### **Whale Tail Open Pit - 2020 Annual Inspection**

## **RE: Amaruq Mine - Whale Tail Open Pit - 2019 Annual Inspection**

### **Amaruq Project - Whale Tail Open Pit - 2020 Annual Inspection**

## Northwest Wall Overview

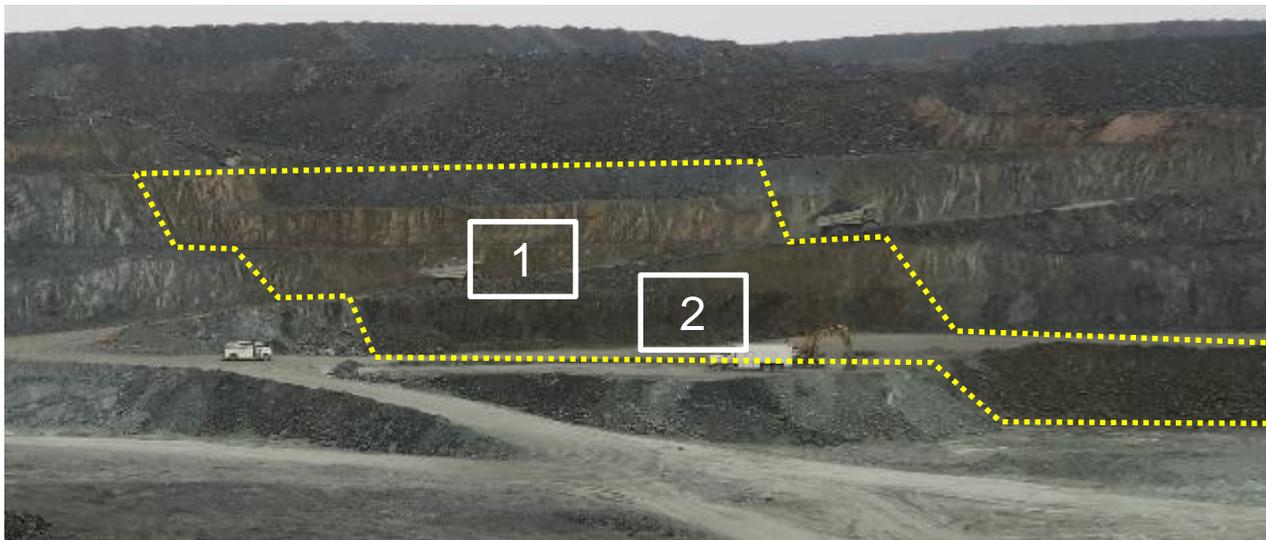
- The upper two benches will form part of the final wall in Design Sector A1. The lowest bench is an interim wall.
- With two exceptions, the wall is generally performing well. These exceptions are discussed in greater detail later in this presentation.
  - The oxidized greywacke was not previously identified during the design of the open pit. It is of lower quality than the greywacke and is generally performing poorly.
  - The interim 7 m high bench in the Komatiite was originally 21 m high and performed poorly over the summer.
- Prior to the inspection, a possible wedge was scaled down in the komatiite (circled in red).

## Northwest Wall – Oxidized Greywacke

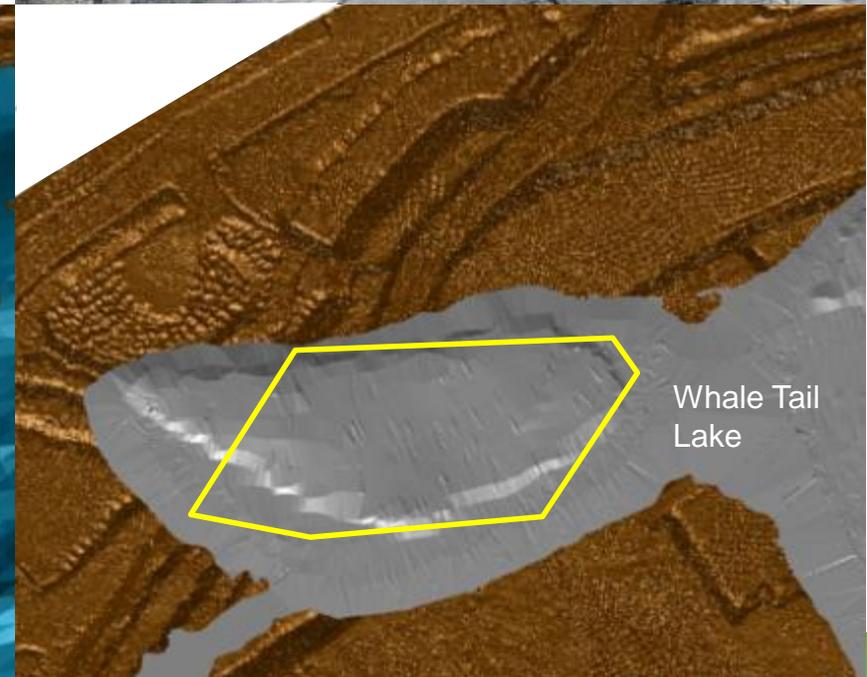
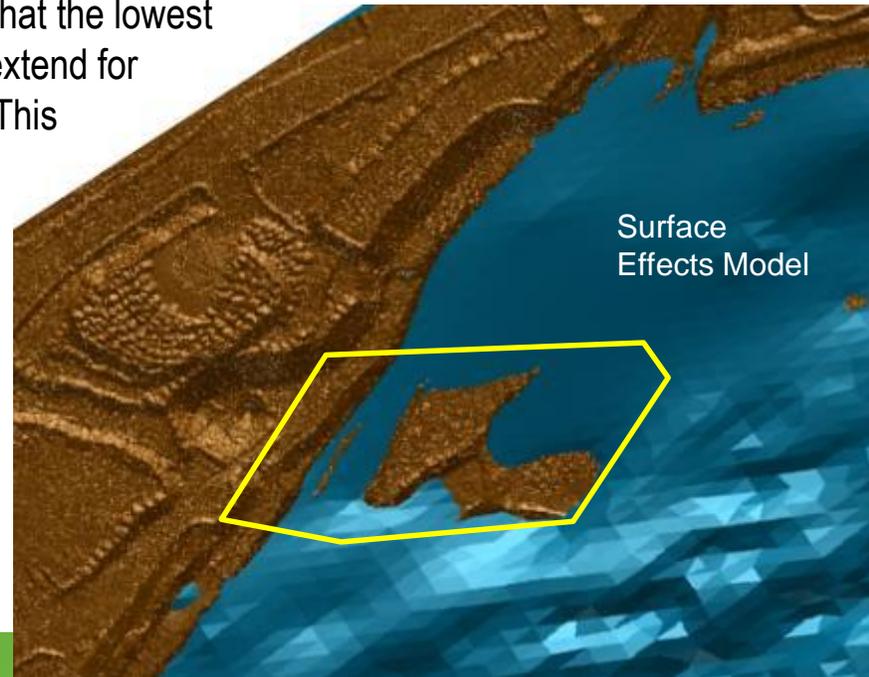
- The southern contact of the oxidized greywacke appears to be defined by the contact with the Komatiite. The northern boundary may be gradational.
- The oxidized greywacke appears to be associated with the western lobe of Whale Tail lake (see bathymetry overlain on July pit shell at lower right).
- The area also corresponds to a region of reduced RQD incorporated into a “surface effects” region of the brittle structural model (volume above blue surface in lower left image)
- The brittle structural model suggests that the lowest quality oxidized greywacke will only extend for approximately one more 7 m bench. This should be considered approximate.
- If the oxidized greywacke extends deeper than predicted, it will be necessary to consider how best to manage the rockfall hazard (e.g. increasing bench width directly below this unit).

## Northwest Wall – Iron Formation

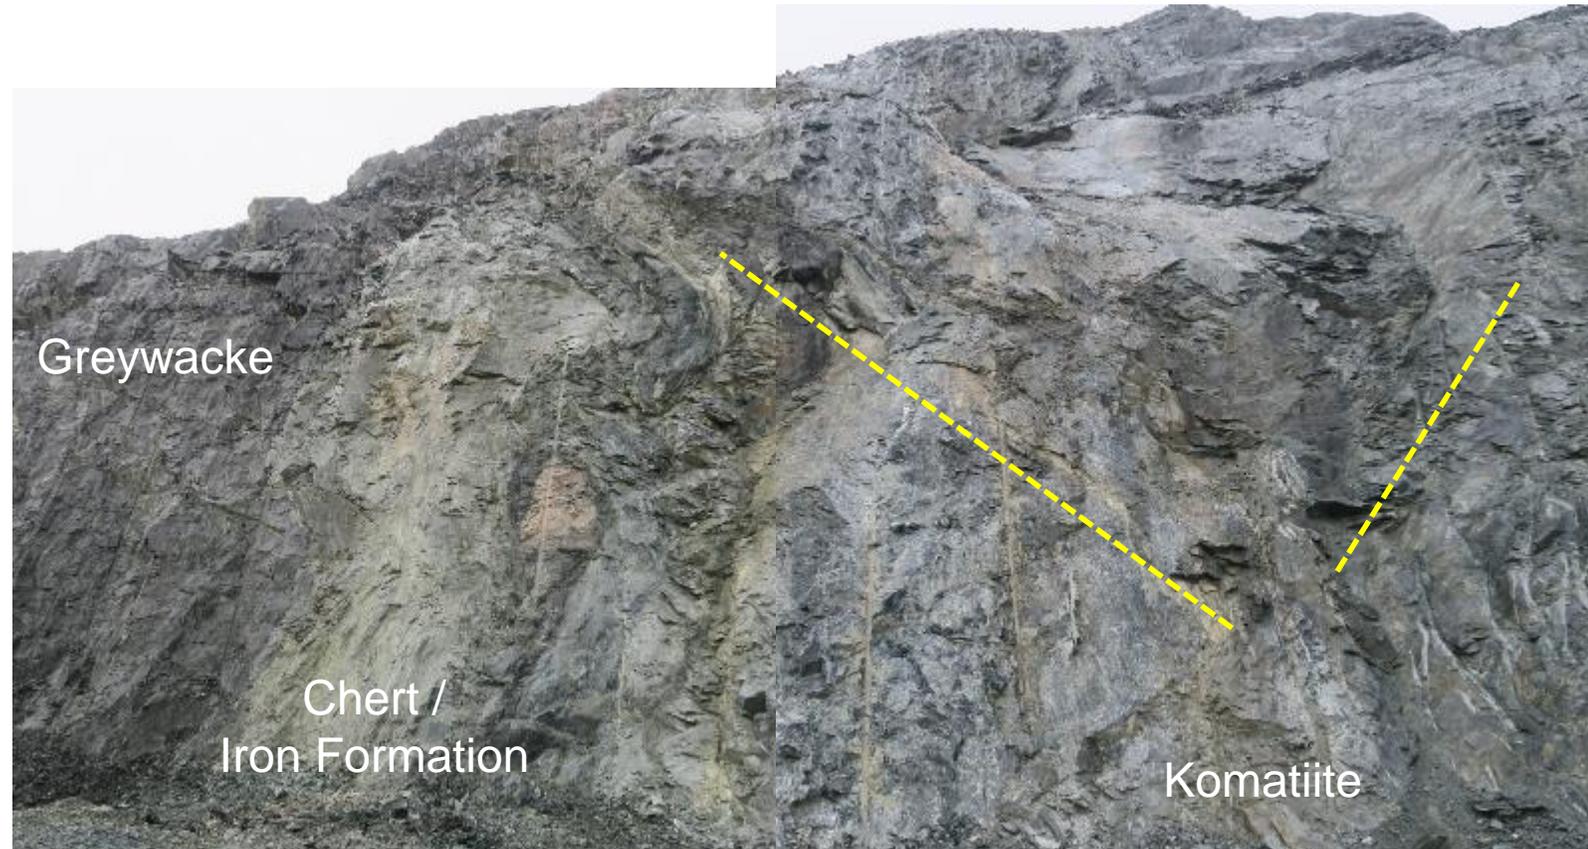
- Benches performing reasonably well. Half barrels present on most places but there has been some ravelling of the crest and face.
- Previous lithology models predicted that Iron Formation would be present in this wall, and the darker material was confirmed to be magnetic during the inspection. However, the most recent lithology model removed the Iron Formation from this area and predicts it to be Komatiite. The lithology should be confirmed with geology.

## Northeast Wall

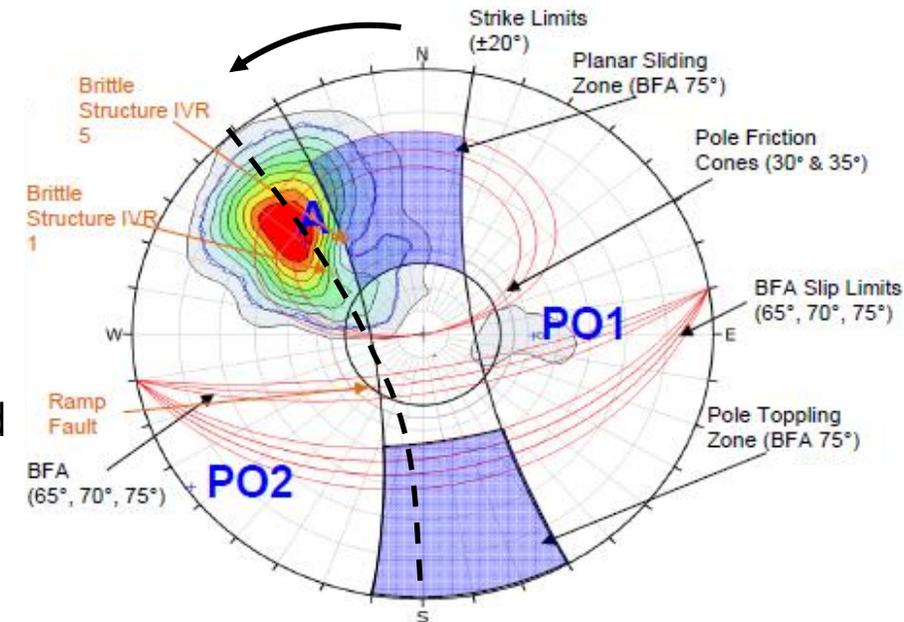
- Final wall in the Komatiite in Design Sector D4, 14 m in height.
- The upper 7 m bench has broken back to the foliation, while the lower 7 m bench has held at the design bench face angle of  $75^\circ$  (steeper than the foliation). The reason for this is not currently known. Possible causes include variation in scaling practices, blasting practices, discontinuity strength, etc.
- The dip of the foliation is estimated to be approximately  $45$  to  $50^\circ$  (to be confirmed). The foliation was expected to have an average dip of between  $55$  and  $60^\circ$  in this sector.

## Performance of the Komatiite

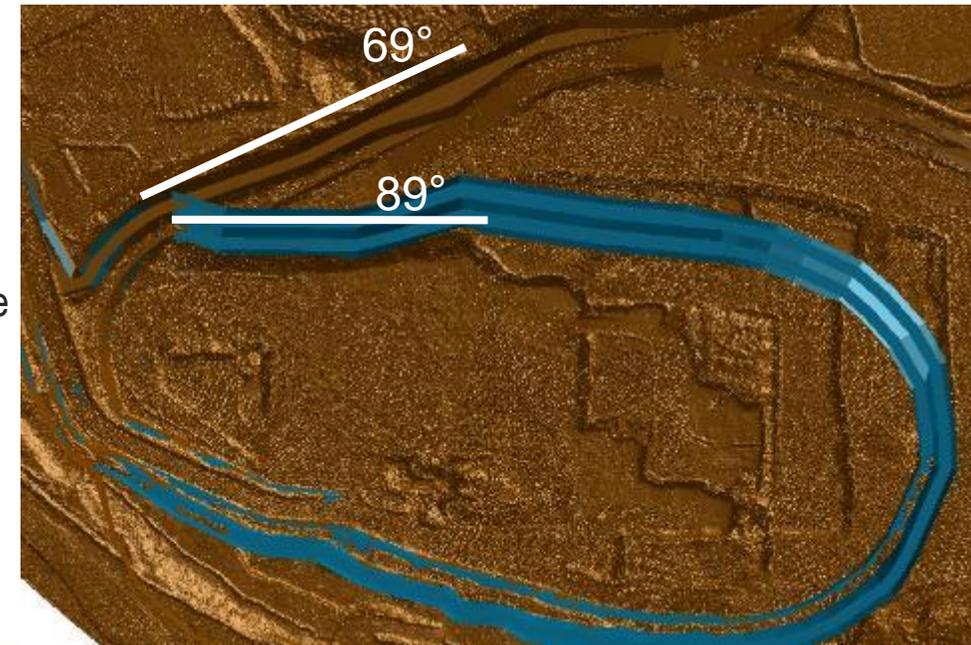
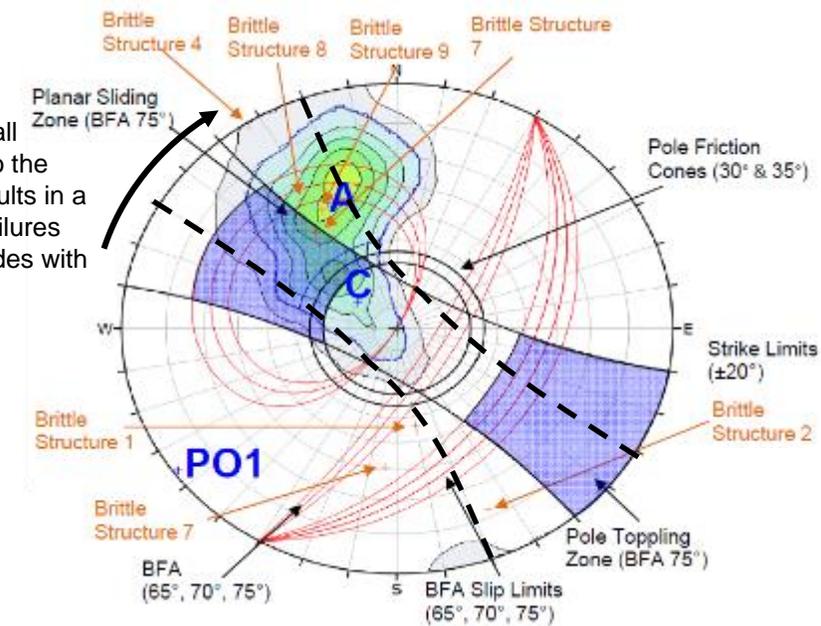
June 28, 1122 tonnes

## Adjustments to Slope Design

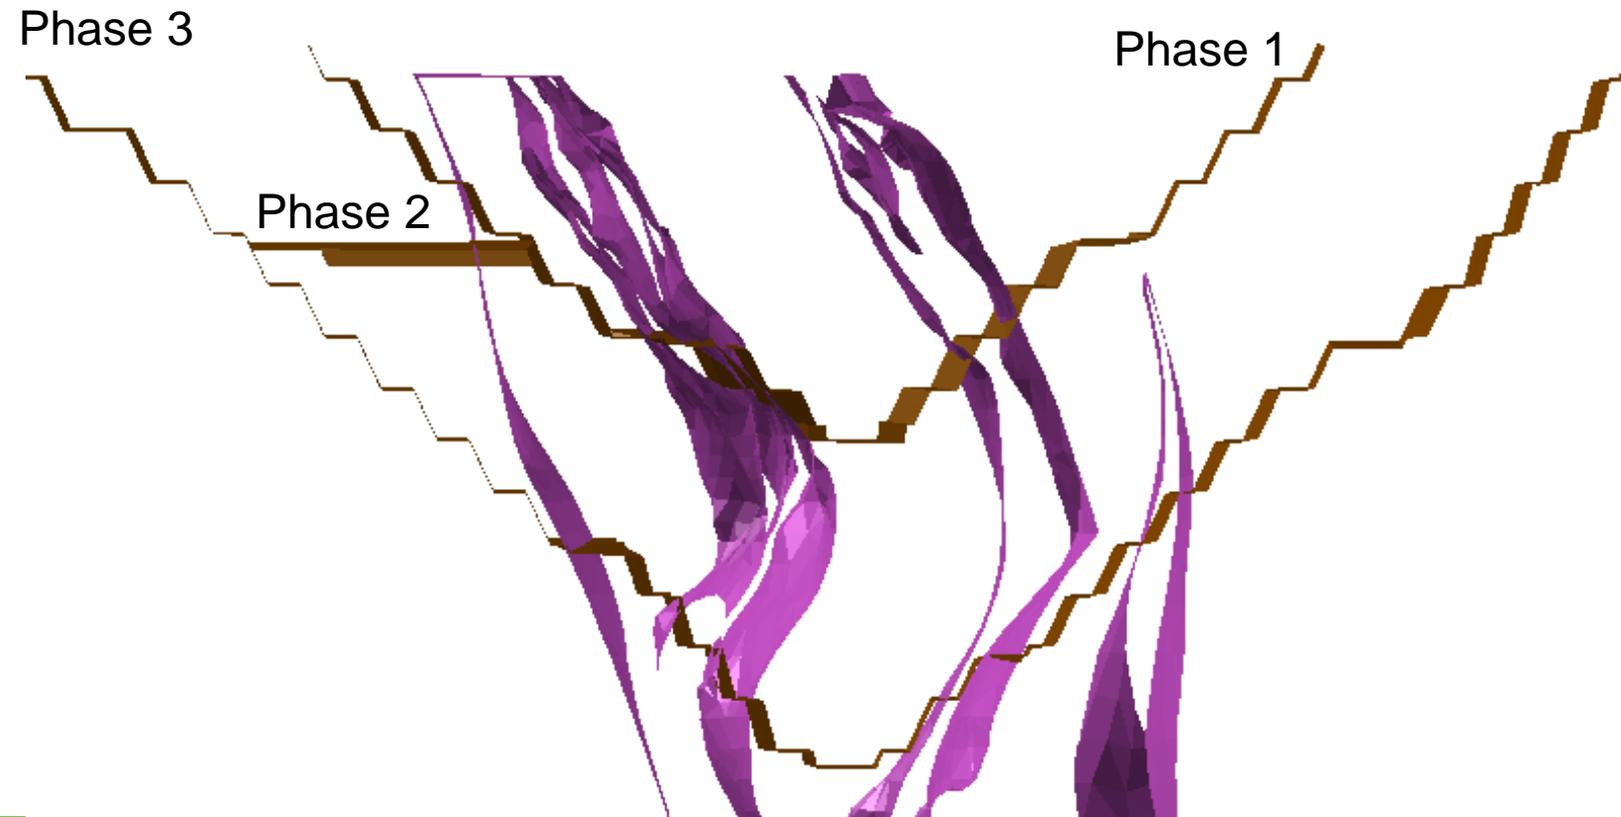
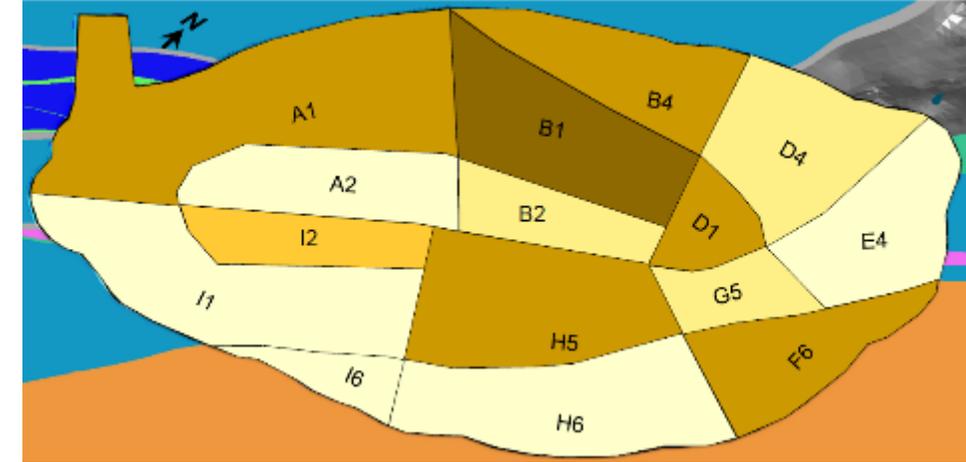
- It is important to note that the objective here is to reduce the frequency of the failures, not prevent them. Some failures will still occur due to the variability in the orientation of the foliation, particularly within the Komatiite.
- An example of the local variation in the dip of the foliation encountered over a 21 m bench in the komatiite is shown at right.

## Slope Stability Radar

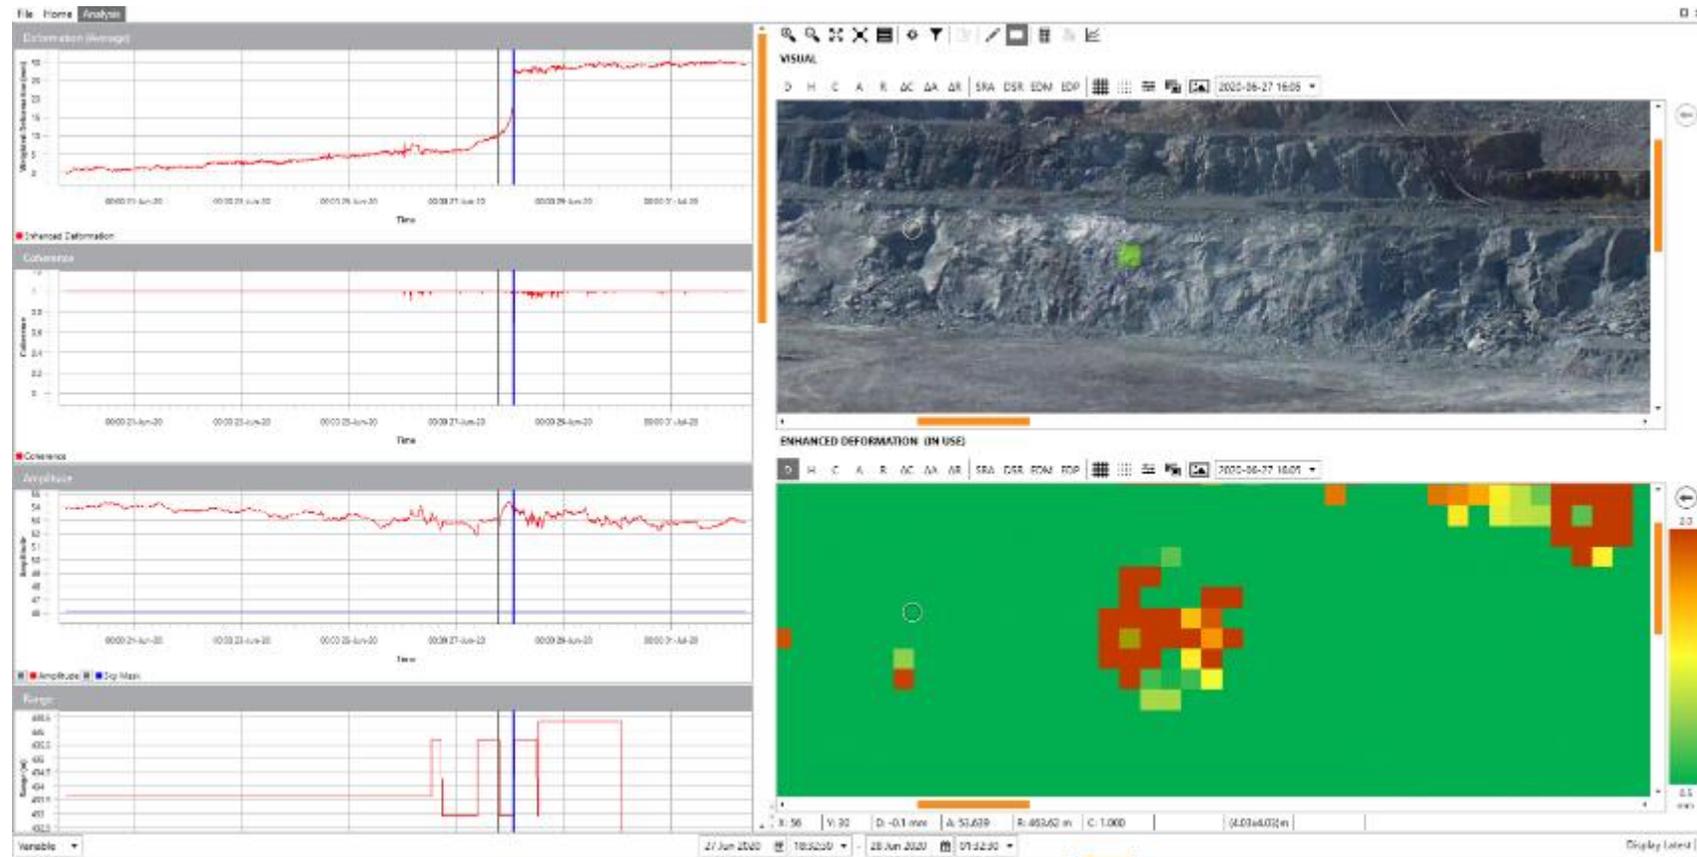
- The SSR is not always able to predict the bench scale failures that have occurred at the mine. This is primarily a function of the scale of the failure relative to the resolution of the radar, and how rapidly they occur.
- For example, the SSR predicted the June 29 failure (which was a continuation of the June 23 failure) only a few hours in advance and might not have triggered an alarm.

## Groundwater

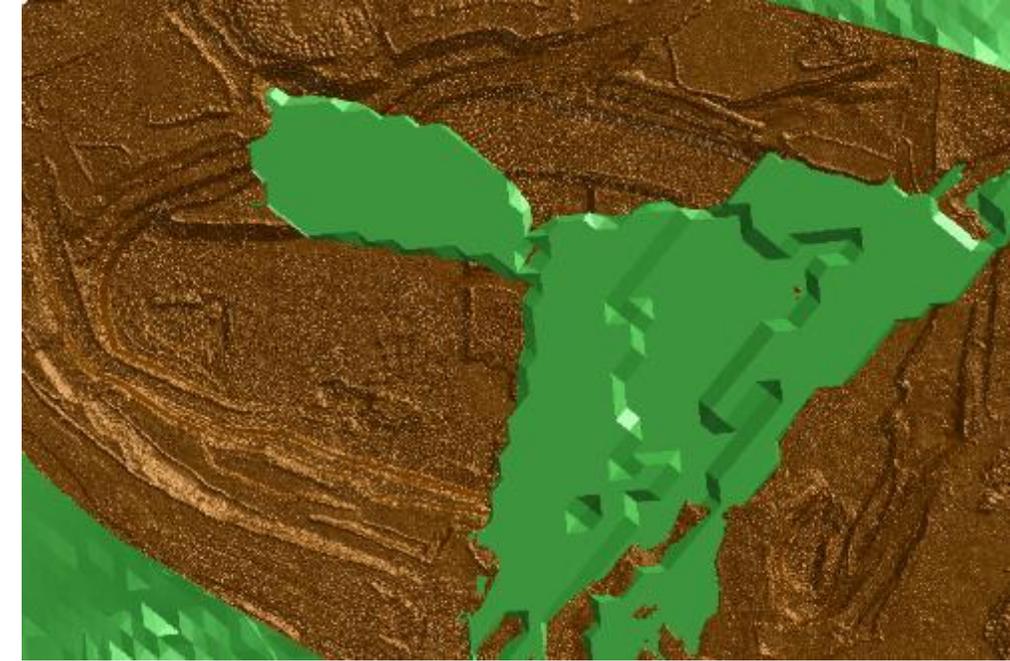
- While seeps have not been observed to date in the south/southeast walls, a significant accumulation of groundwater has been noted in the floor of the pit and the drillers report water when drilling in the area approximately outlined in yellow.
- During the visit, a driller also reported water filling his holes and then freezing in the area outlined in white.
- The areas where groundwater is accumulating in drillholes or on the pit floor agree well with the extents of the talik/cryopeg predicted by the thermal model (Cryopeg predicted by Scenario 2 shown at upper right in green). The source of the water is discussed on the next slide.

## Groundwater

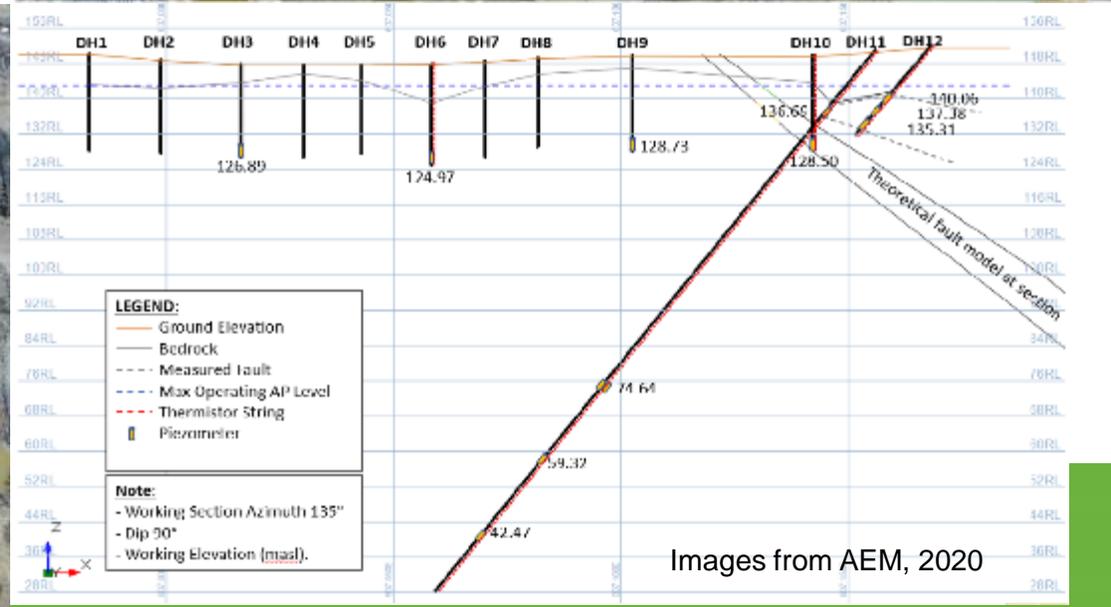
- AEM installed a series of piezometers and thermistors along the planned crest of the ultimate pit where it will be adjacent the attenuation pond and the lakebed of Whale Tail lake. The objective was to determine if the pond was the source of the water in the floor of the pit.
- The results suggest that water is flowing from the attenuation pond towards the open pit within the near-surface bedrock, as well as deeper fractured zones. There is a rapid response observed in the instruments (both piezometers and thermistors) when the water level in the attenuation pond rises (shown on next slide).
- Additional sensors are planned to better define the flow path to the open pit; this is encouraged.
- No evidence of flow along the Ramp Fault was observed in the instrumentation.
